# Access Compliance Report

## Public Rights-of-Way

Intersection ID: 32287	Main Street: ALLYSON PARK DR	Cross Street: BAILEYWICK RD	Location: SE
ADA ID: F47F231B8FE7	Ramp Type: PerpDiag	Initial Pass/Fail: Fail	Overall Compliance: No
Codes/Mitigation Info/Possible Solution		Field Measurements/Component Compliance	
Severity Score: 21.25

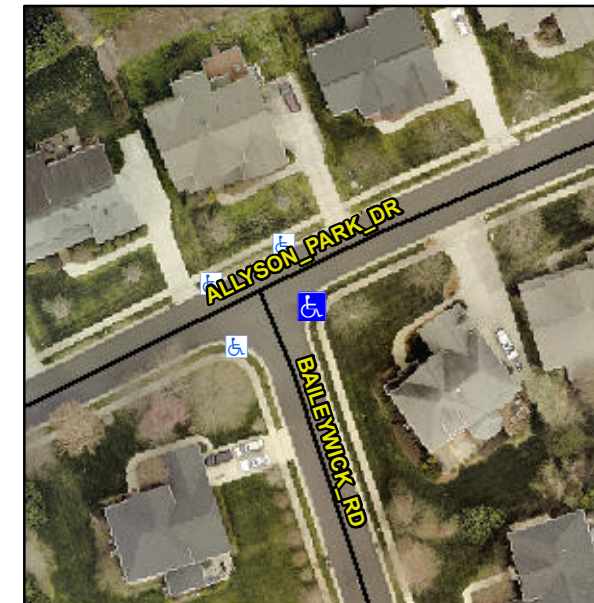
**Not Found, R304.5.1, R304.5.3**

Compliance	Description	Data	Compliance	Description	Data
N/A	Ramp Length (in)	47.5	Yes	Ramp Slope (%)	7.5
No	Ramp Width (in)	47.5	No	Ramp XSlope (%)	5.5
N/A	Flare Type LT	N/A	N/A	Flare Type RT	N/A
N/A	Flare Slope LT (%)	N/A	N/A	Flare Slope RT (%)	N/A
N/A	Flare Traversable LT?	N/A	N/A	Flare Traversable RT?	N/A
N/A	Landing Length (in)	N/A	N/A	DWS Provided?	N/A
N/A	Landing Width (in)	N/A	N/A	DWS Contrast?	N/A
N/A	Landing Slope (%)	N/A	N/A	DWS Length (in)	N/A
N/A	Landing X Slope (%)	N/A	N/A	DWS Full Width?	N/A
N/A	Landing Curb? (Y/N)	N/A	N/A	DWS Offset (in)	N/A
N/A	Shared Landing?	N/A			
N/A	Gutter Ponding?	N/A	N/A	Gutter Slope (%)	N/A
N/A	Gutter Lip Ht (in)	N/A	N/A	Gutter X Slope (%)	N/A
N/A	Painted X Walk1?	No	N/A	Painted X Walk2?	No
	X Walk 1 Direction	To N		X Walk 2 Direction	To W
N/A	X Walk 1 Width (in)	N/A	N/A	X Walk 2 Width (in)	N/A
	X Walk 1 Slope (%)	0.8		X Walk 2 Slope (%)	5.0
	X Walk 1 X Slope (%)	5.0		X Walk 2 X Slope (%)	1.2

**Remove & Replace Curb Ramp With Two New Directional Ramps or Equivalent.**
